**MEMORANDUM**

April 21, 2017

TO: County Council   
FROM: Marlene Michaelson, Senior Legislative Analyst  
SUBJECT: Bethesda Downtown Sector Plan

Acura Site Shadow Study  
200 ft building height

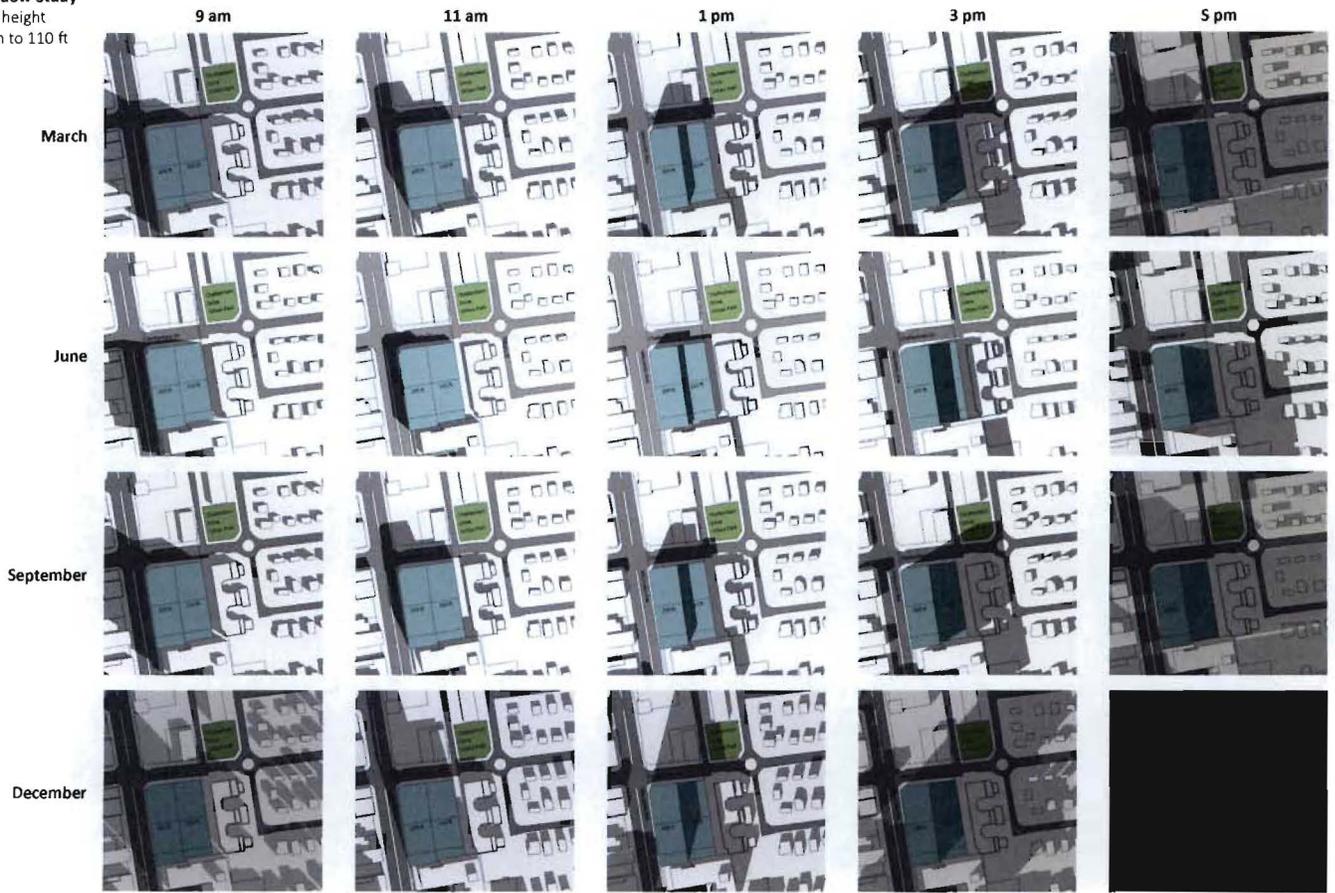
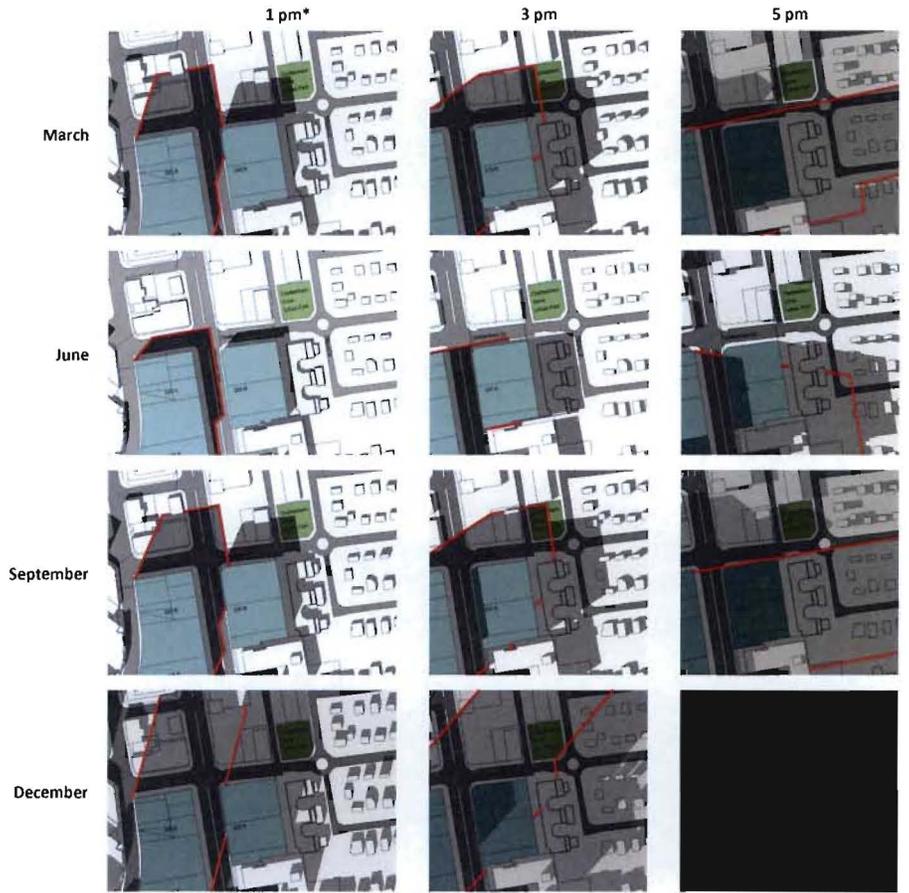
The description of these properties and the Committee recommendation from the April 18 Staff memorandum follows below. Attached on © 63-72 are the shadow studies requested by Councilmembers Riemer and Katz for the Chevy Chase Acura property (7725 Wisconsin Avenue – Area #87), the Wells Fargo Bank property (7901 Wisconsin – Area #90) and the Saul property (8001 Wisconsin Avenue – Area #92) with different height buildings. It is worth noting that the shadow studies assume the entire property will develop at the same height even though the Sector Plan calls for a step-down of heights on some properties.

**Committee Recommendation: The majority supports the FAR recommended by the Sector Plan, but recommends reducing the height from 250 feet to 200 feet. Councilmember Riemer supports the Council Staff recommendation for 145 feet.**

The Acura Dealership (Area 87, Wisconsin Avenue North - see map on © 81) is currently zoned for a height of 90T. The Planning Board recommended increasing the height to 250 feet because this property is located at a corner they believe should have a new node of development and height. (This property

will be directly across the street from the new Marriott headquarters, but the Planning Board was not aware of Marriott's location when it finalized its recommendations.) The majority believes the height should be reduced from the Sector Plan recommendation to 200 feet. Councilmember Riemer supported the Council Staff recommendation for 145 feet as a transition from the 300-foot zoning on the Marriott property to the West and the single-family homes to the east.
